Discontinuation Notification

To: Global Micro Motion Customers
cc: Global Micro Motion Sales
From: Tonya Wyatt
Date: June 25, 2010
Subject: Product Discontinuance – Analog RFT9739 Rack and Field Mount Transmitters

Replacement of RFT9739E/D (field mount version) with 9739 with MVD Technology

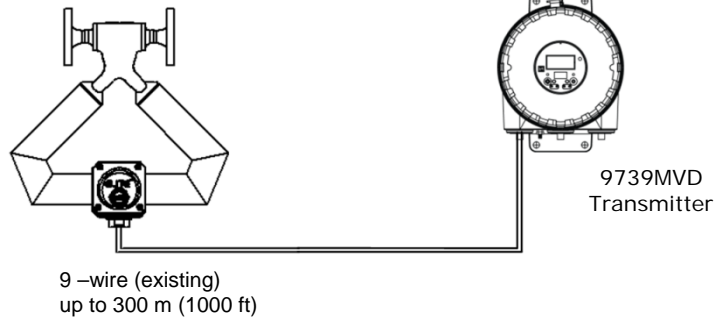
Option 1

A **retrofit kit** can be used if:

- the existing transmitter model number starts with RFT9739D4, RFT9739D5, RFT9739E4, or RFT9739E5
- the existing transmitter serial number begins with 17, 18, 2, or 7.

A **complete transmitter** is required if:

- the existing transmitter model number starts with RFT9739E1, RFT9739E2, or RFT9739E3
 - the existing transmitter serial number begins with 15.
-

Replacement of RFT9739E/D (field mount version) with 2700 with MVD Technology

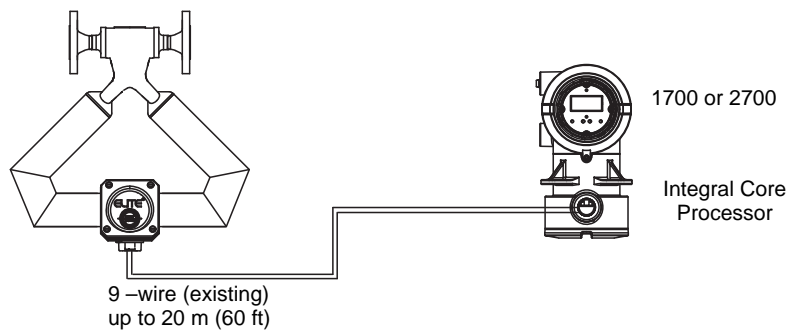
Option 2

Replacement of RFT9739R (Rack mount version) with 2500 with MVD Technology

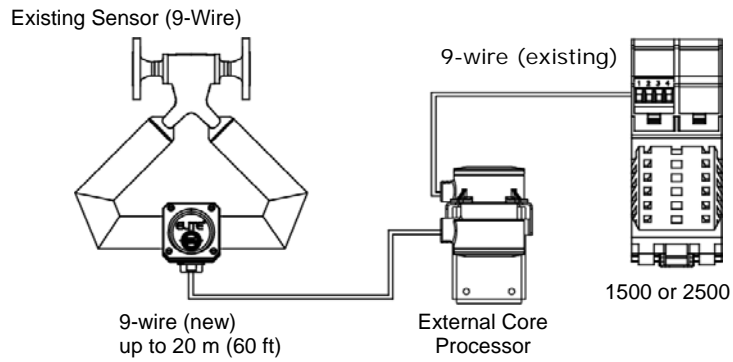
Option 3
